S213-07/08

2302, 2303.1, 2303.1.12 (New), Chapter 35 (New)

Proposed Change as Submitted:

Proponent: John Woestman, The Kellen Company, representing Composite Lumber Manufacturers Association

FIGURE 2308.3.2 (1)
BRACED WALL PANEL TOP PLATE CONNECTION.

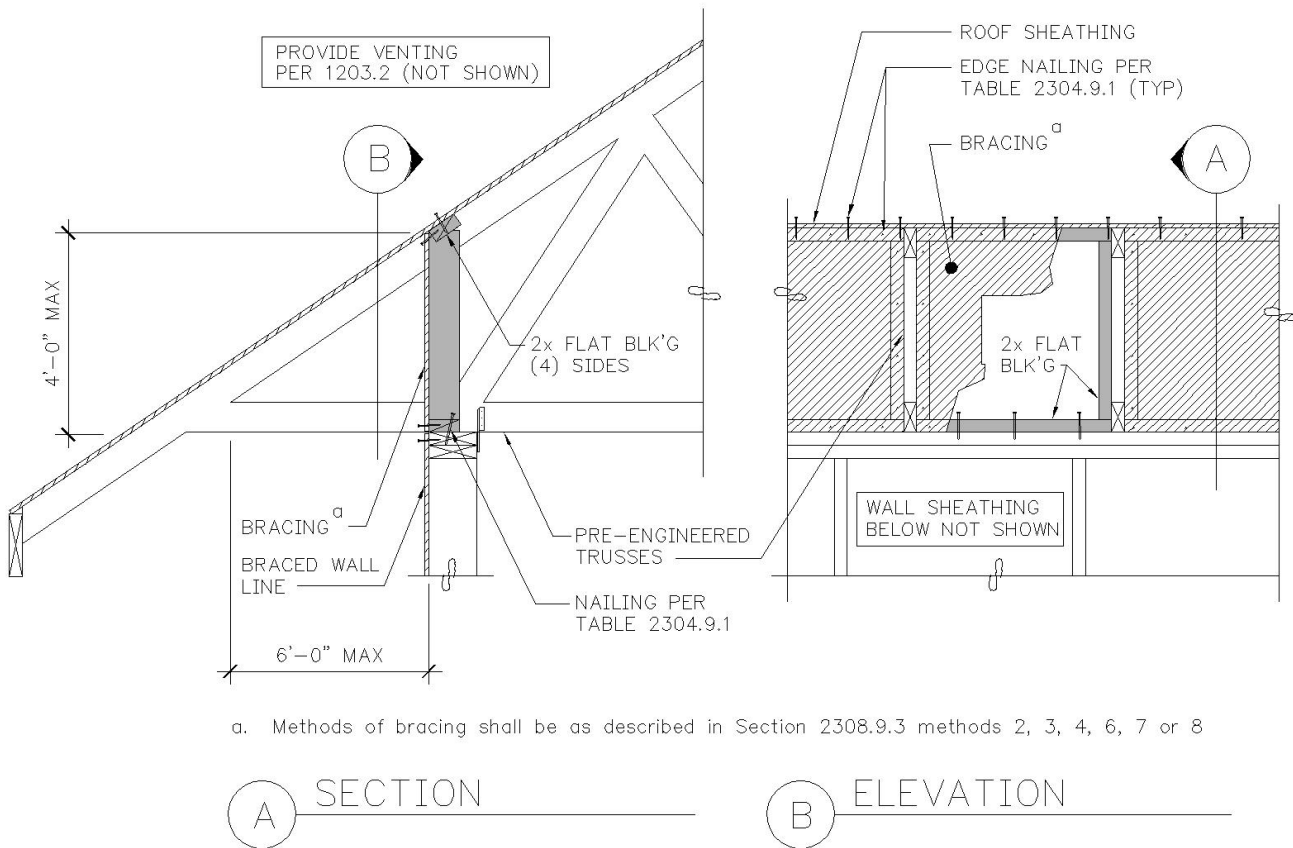
2308.3.2.2 Braced wall panel connections to roof framing. Braced wall panels shall be connected to roof framing as follows:

1. A parallel framing member or partial-height solid blocking between perpendicular trusses or rafters shall be provided and extend from the top plate to within 2 inches of the bottom side of the roof sheathing. Blocking shall be nailed to the top plate below with not less than 3-8d toenails per block.

- 2.1. In accordance with Figure 2308.3.2 (1)
 - 2.2. In accordance with Figure 2308.3.2 (2)
 - 2.3. With full height engineered blocking panels designed for values listed in American Forest and Paper Association (AF&PA) Wood Frame Construction Manual for One- and Two-Family Dwellings (WFCM). Roof or floor sheathing above shall be attached to the blocking panels and the blocking panels shall be attached to top of wall in accordance with Table 2304.9.1

**FIGURE 2308.3.2 (1)
BRACED WALL PANEL TOP PLATE CONNECTION.**

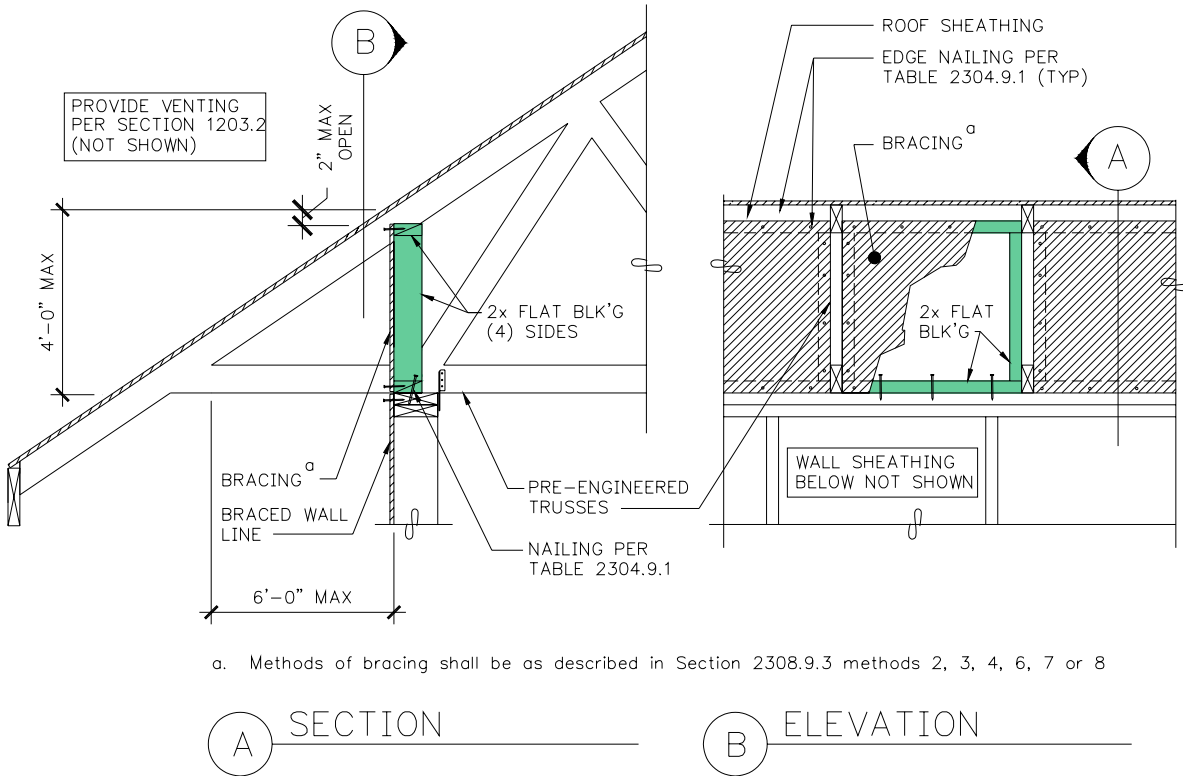
2308.3.2.2 Braced wall panel connections to roof framing. Braced wall panels shall be extended and fastened to roof framing at intervals not to exceed 50 feet (15 240 mm) between parallel braced wall lines. Braced wall panels shall be connected to roof framing as follows:

1. A parallel framing member or partial-height solid blocking between perpendicular trusses or rafters shall be provided and extend from the top plate to within 2 inches of the bottom side of the roof sheathing. Blocking shall be nailed to the top plate below with not less than 3-8d toenails per block.

- 2.1. In accordance with Figure 2308.3.2 (1)
 - 2.2. In accordance with Figure 2308.3.2 (2)
 - 2.3. With full height engineered blocking panels designed for values listed in American Forest and Paper Association (AF&PA) Wood Frame Construction Manual for One- and Two-Family Dwellings (WFCM). Roof or floor sheathing above shall be attached to the blocking panels and the blocking panels shall be attached to top of wall in accordance with Table 2304.9.1
